**RE: Tellier Pit M-1998-058**  
**Technical Revision 02, Adequacy Response 3**

Map F-1 Reclamation Plan

Tellier Pit

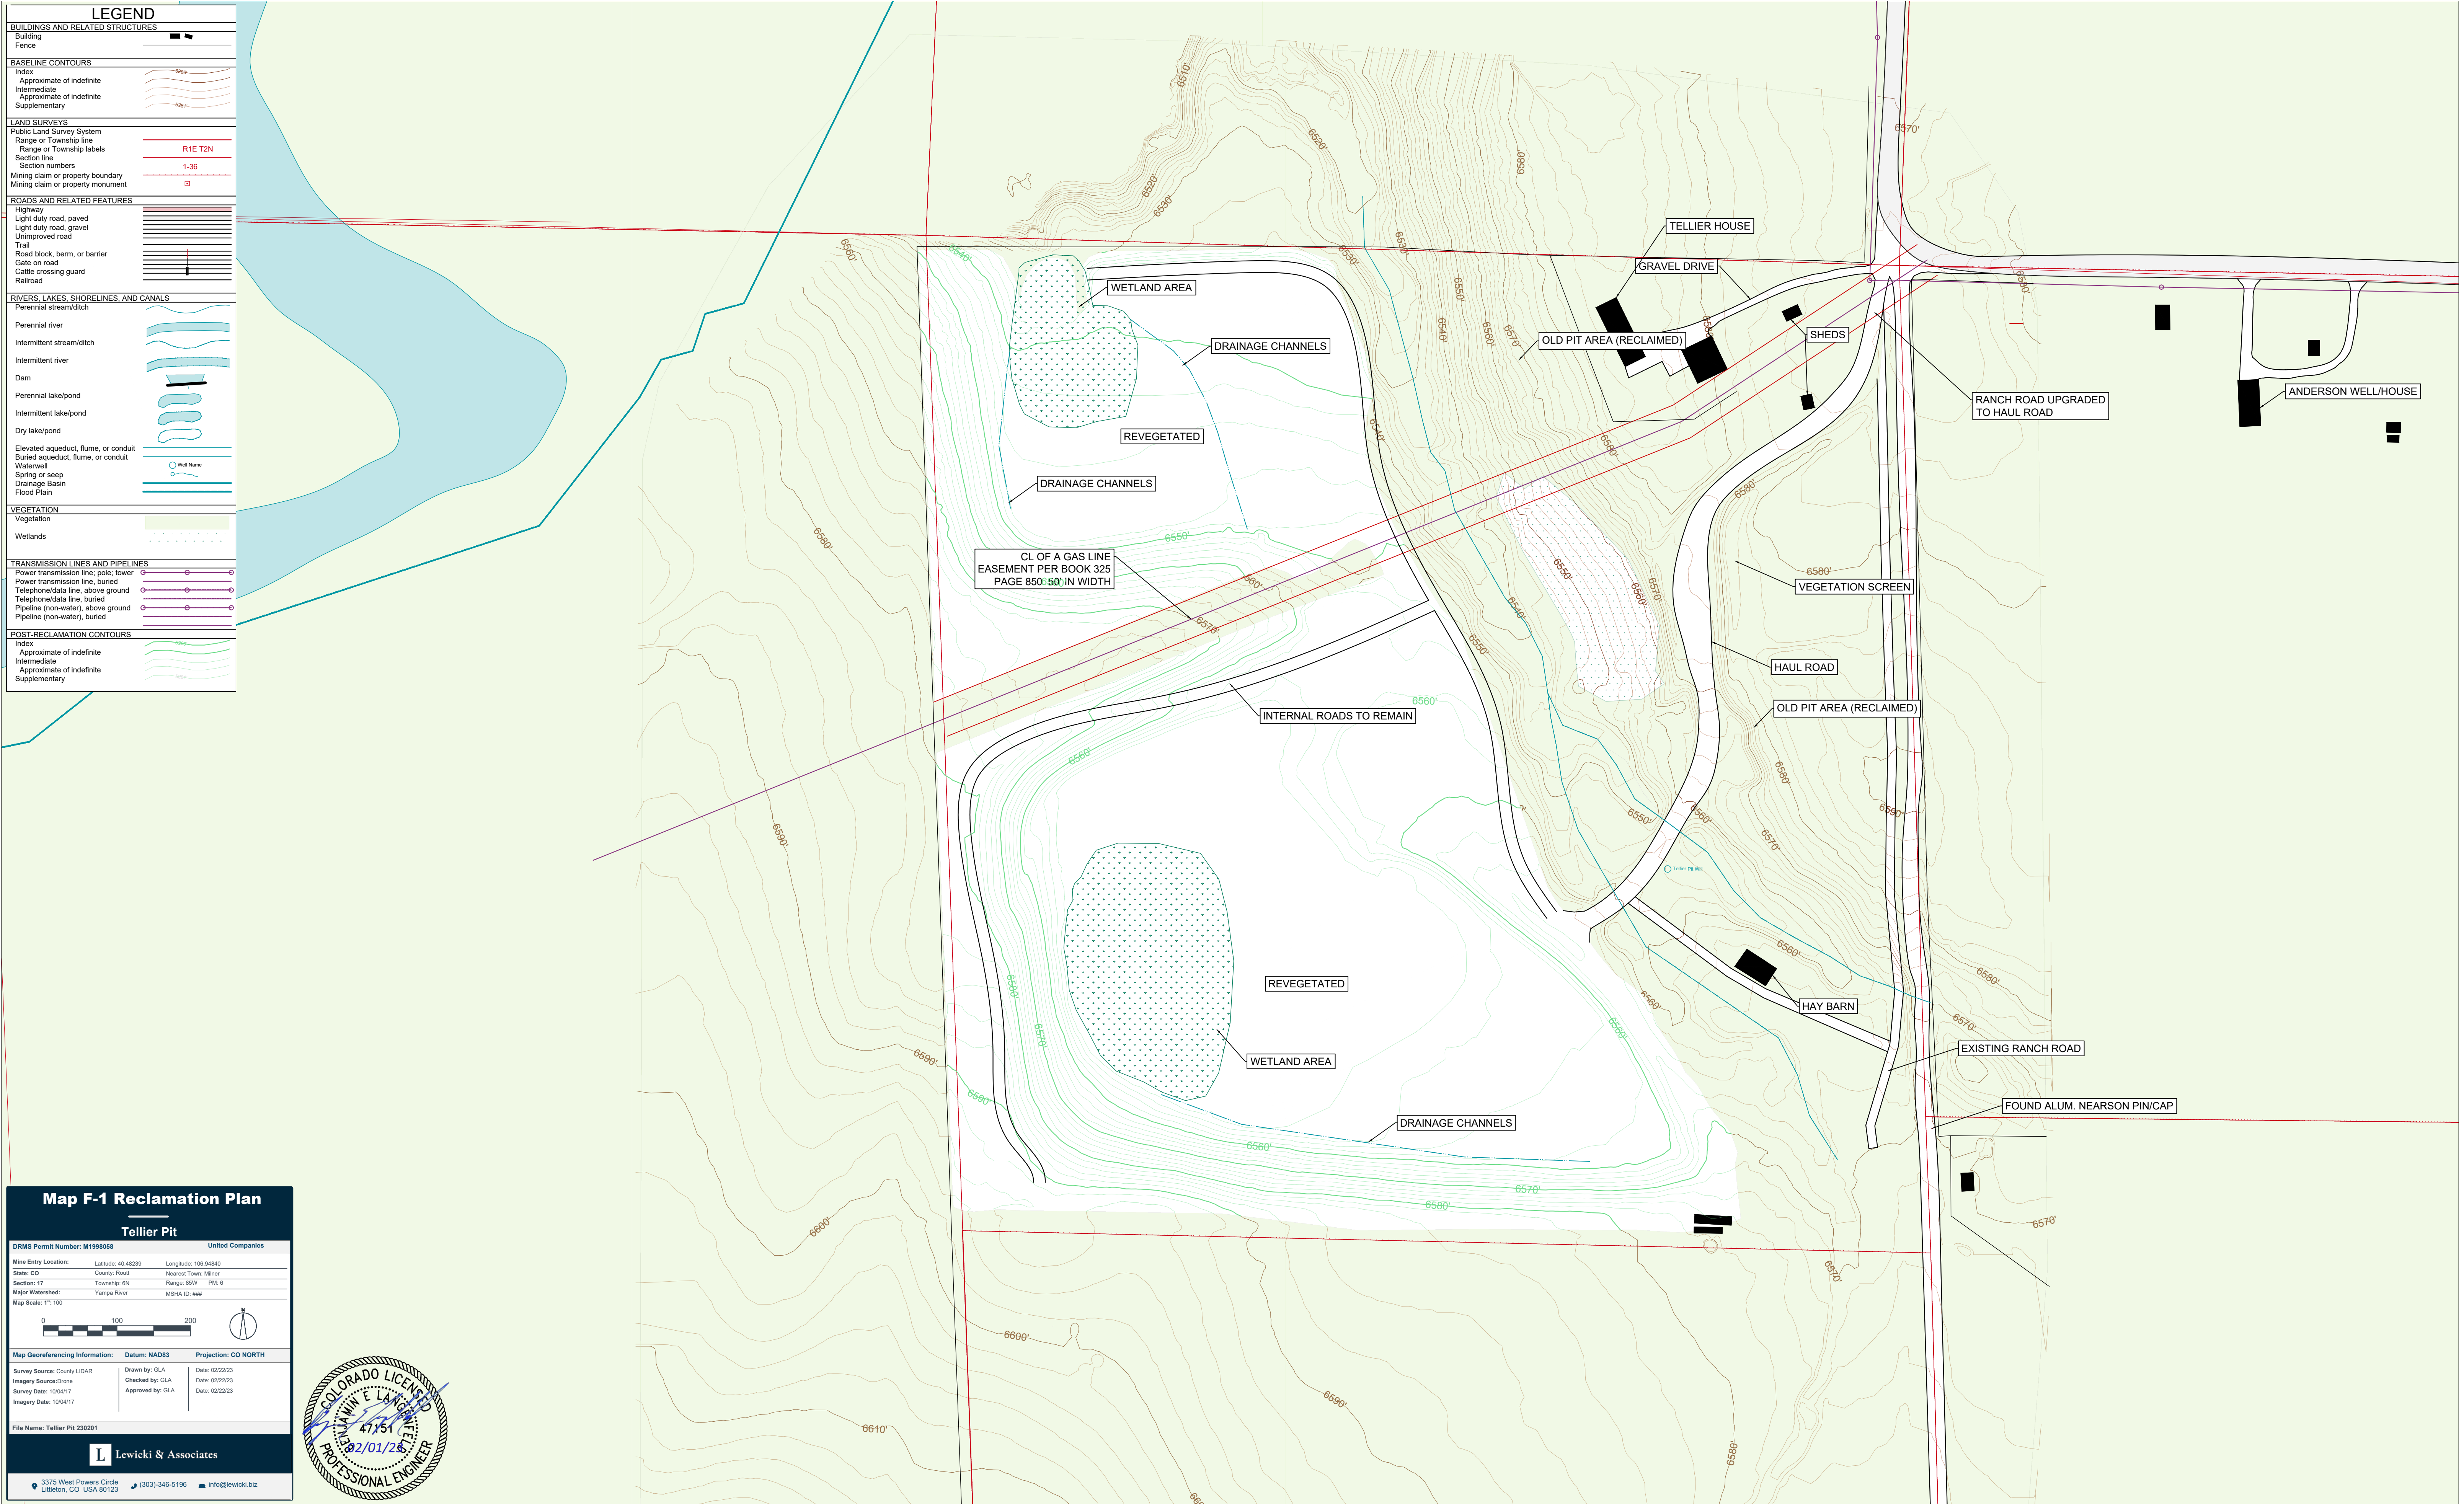
*In response to Item 8, you provided a revised version of the updated Reclamation Plan Map. This revised map now contains two wetland areas, one in each of the mining areas, however their size and location do not match the previously approved plan. Additionally, in response to Item 2 you have already clarified that the TR2 catchment area is in addition to the wetland areas, however the revised map shows the catchment area now replaces the wetland area for the Phase II Mine Block. Lastly, the three drainage ditches which carry surface water to supply the wetlands are not included on the map. The permit record reflects the approved wetland areas were to offset the impacts of the access road crossing the drainage and associated wetlands that were determined by an informal wetlands investigation and then a subsequent site visit by the the U.S. Army Corps of Engineers (USACE). The approved wetland areas were also proposed to fulfil a request by the Division of Wildlife (now CPW) to mitigate wildlife impacts. During the 1998 permitting process, the Applicant stated they were in the process of preparing a Nationwide Section 14 Road Crossing 404 Permit application and proposed the use of the two wetland areas as mitigation for the 404 permit. Given this, TR2 cannot include a change to the approved wetland areas. You may submit a subsequent Technical Revision if you wish to modify the approved wetland areas. This revision would need to be accompanied by documentation from, or correspondence with, the USACE and CPW regarding the proposed change. At this time, for TR2 to be approved, please submit a revised Reclamation Plan Map with the approved wetland areas and drainage ditches as depicted on the current approved Reclamation Plan Map (received October 26, 1998).*

According to the 1998 permit file the wetlands are to address the entrance road crossing as part of a nationwide permit approval by USACOE and to improve wildlife habitat in reclamation at the behest of Colorado Parks and Wildlife. According to a comment letter from Colorado Parks and Wildlife (then CDOW) to Routt County:

The 1998 reclamation plan map does not specify the acreage of these small wetland areas, but lays out their general location and size. Since the reclamation plan was originally approved in the later 1990s, mining has taken place at Tellier Pit and completed. United Companies personnel are conducting reclamation of the site. The final topographic arrangement of the site is slightly different than that originally proposed in 1998. This necessitates shifting the small wetland areas to locations where they will be more successful: low points where natural water flow will reach them and sustain the wetland vegetation. A revised reclamation plan map (Map F-1 Reclamation Plan) is attached that shows these new locations while maintaining the size of wetland area depicted on the original 1998 reclamation plan map.
